Re: Individual Section 404 updated Permit Application Materials
Derry-Londonderry, 13065 (Exit 4A)

RESPONSE TO NHDES REQUEST FOR MORE INFORMATION
NHDES # 2018-03134

TROLLEY CAR LANE STREAM RELOCATION
LONDONDERRY, NEW HAMPSHIRE

HYDROCAD™ ROUTING DIAGRAM AND FLOW LOCATIONS

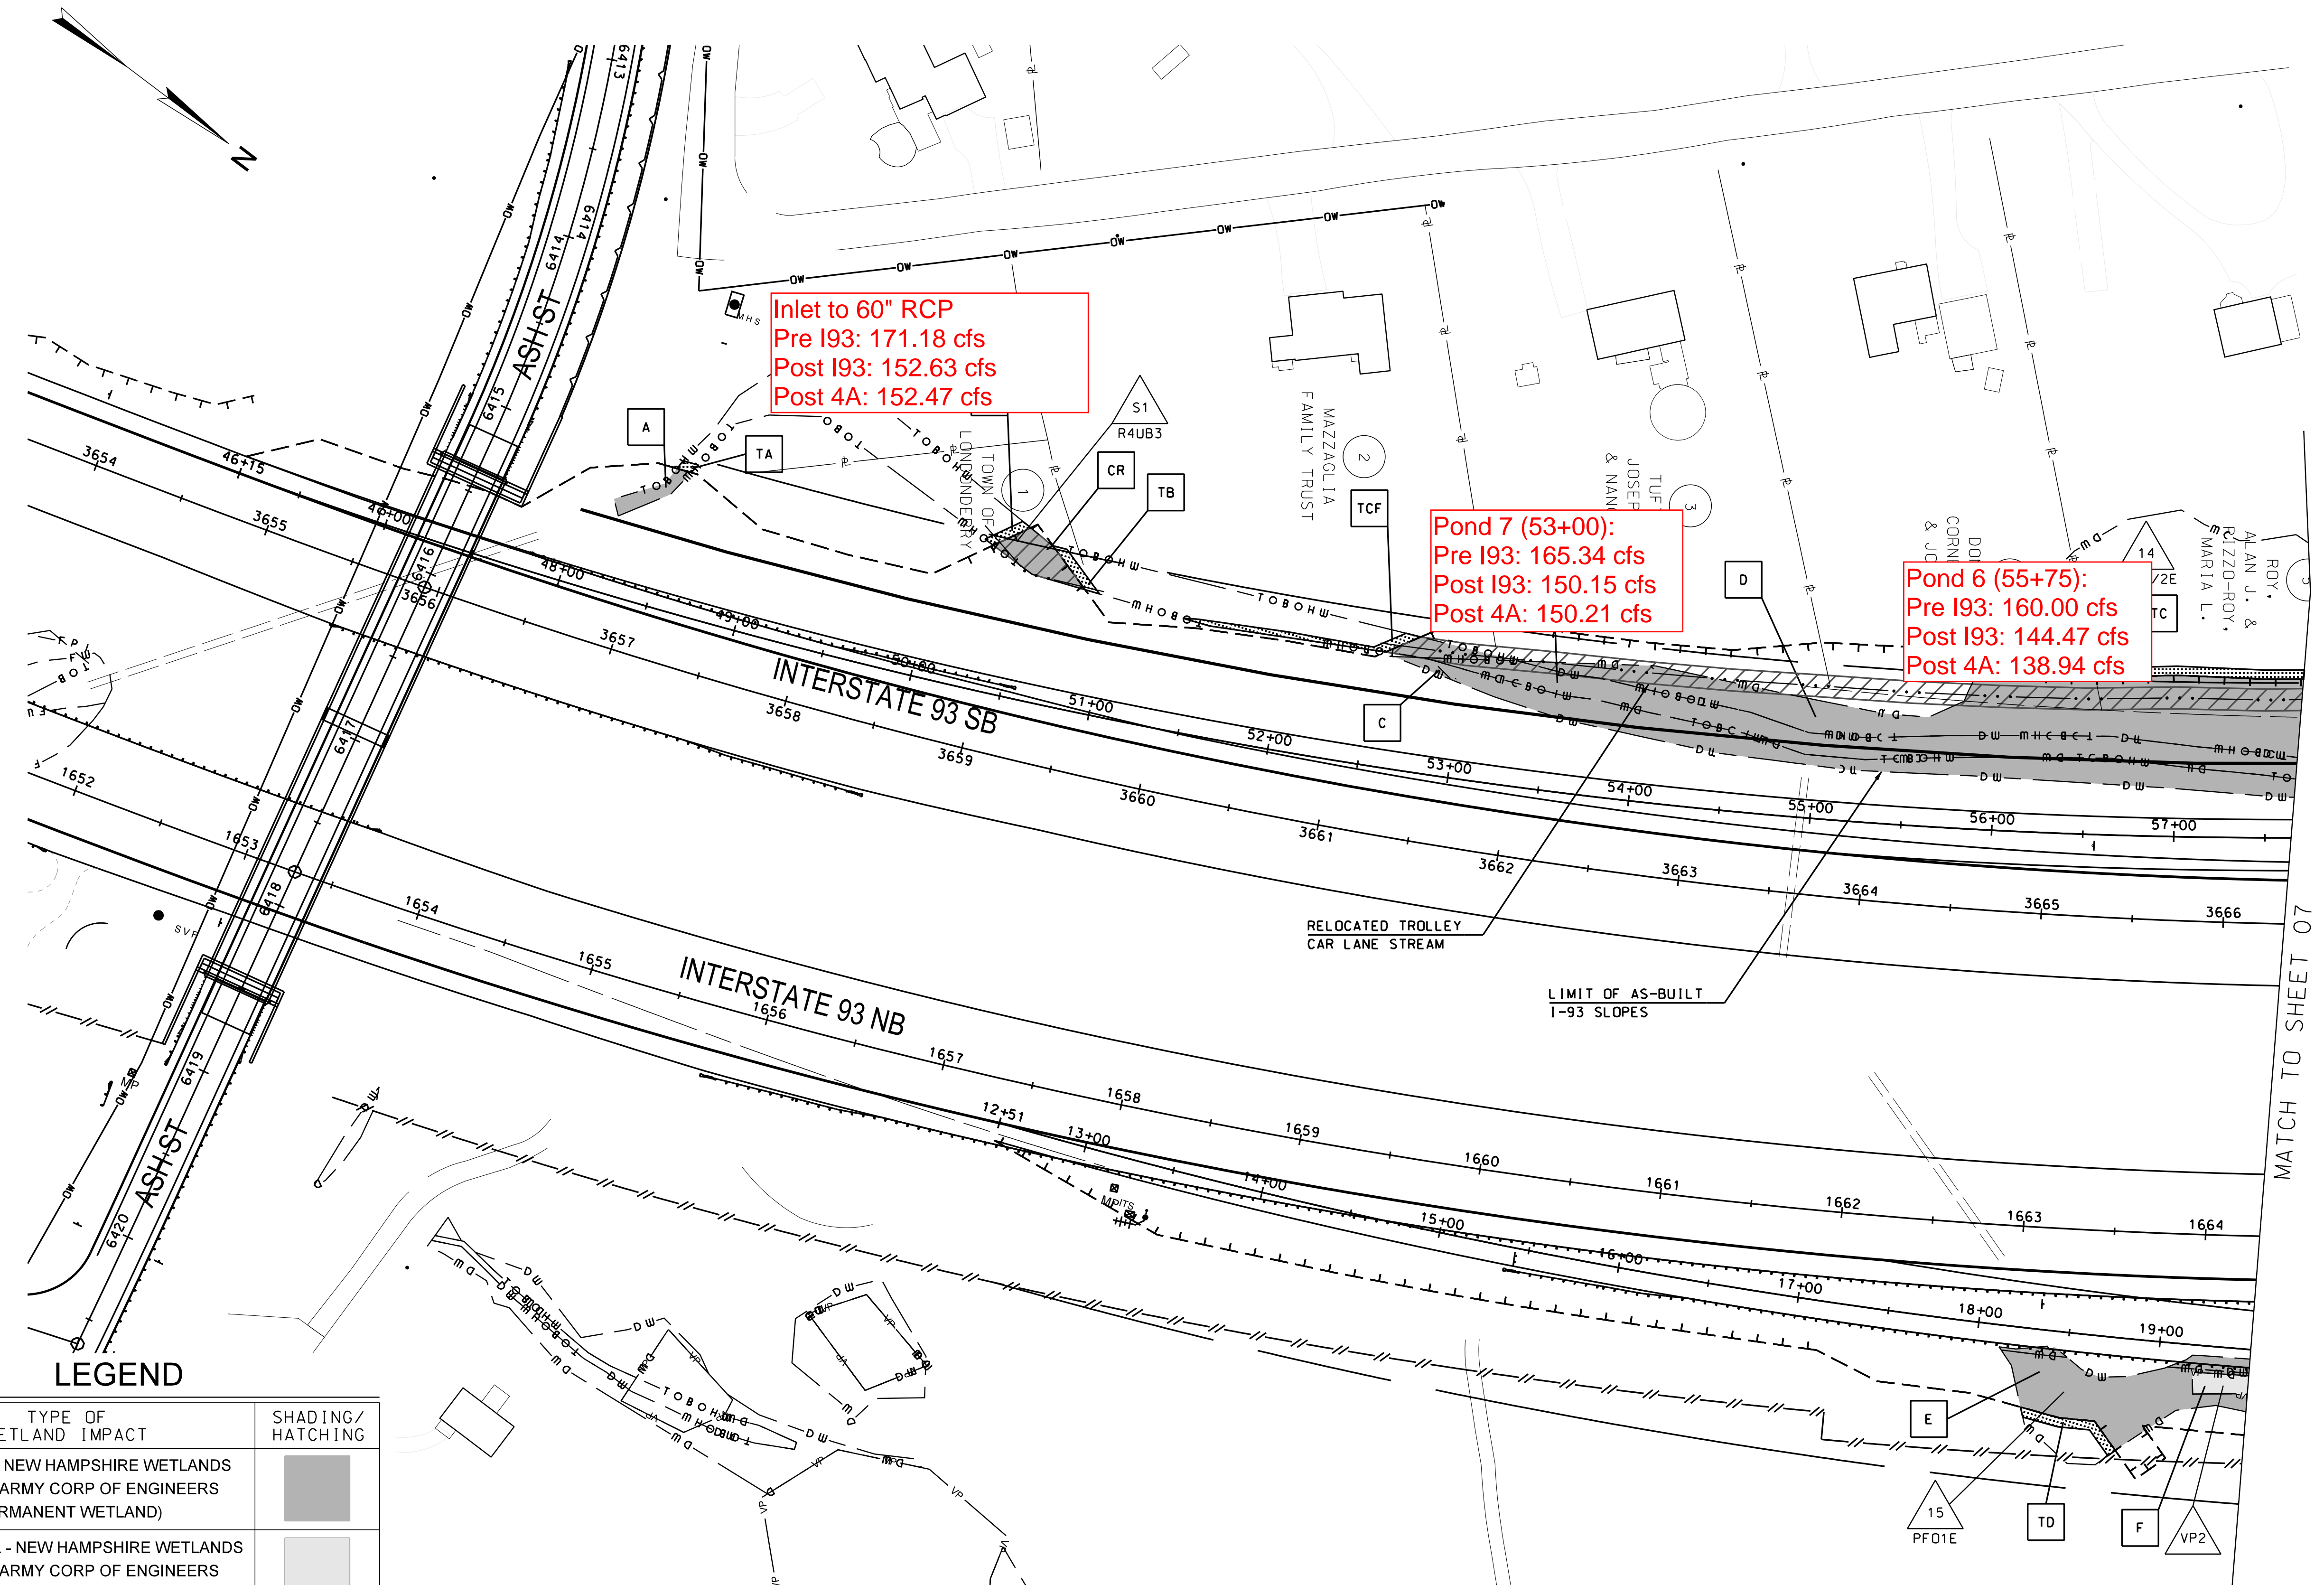
All hydrologic models account for the flows from minor tributaries which contribute to the stream watershed. Within the study reach in particular there are three tributaries which enter from the west side, and three tributaries flowing through three culvert crossing locations from east of I-93 to the stream channel. These locations have been shown on the stream grading plan.

Exit 4A to Post Exit 4A. The HydroCAD™ Routing Diagram for the Post Exit 4A model and a plans depicting the location of the flows below are included in Attachment E for reference. Full hydrologic models are available upon request.

Inlet to 60" RCP
 Pre I93: 171.18 cfs
 Post I93: 152.63 cfs
 Post 4A: 152.47 cfs

Pond 7 (53+00):
 Pre I93: 165.34 cfs
 Post I93: 150.15 cfs
 Post 4A: 150.21 cfs
